## OMG Issue No: 16628

### Title: DiagramElements cannot represent multiple model Elements

Loosen multiplicity of DiagramElement::/modelElement property to \*. Also resolves 16907 by using UML::Element instead of CMOF::Element in the Diagram Interchange metamodel.

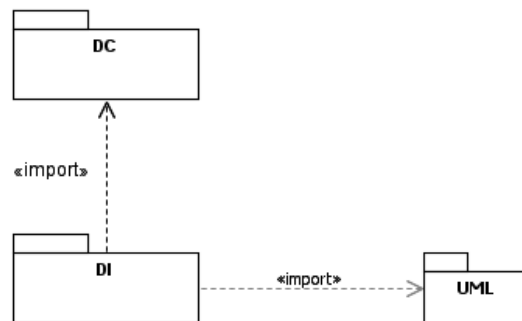
The definition of DiagramElement has an association to the depicted MOF Element with a multiplicity of [0..1]; so, one DiagramElement can represent at most one model Element. However, UML contains at least one notation in which a single symbol represents more than one Element: using a single State symbol to represent multiple similar States (see p.601 of the UML 2.4 Superstructure Specification). Will DD be able to support this notation?
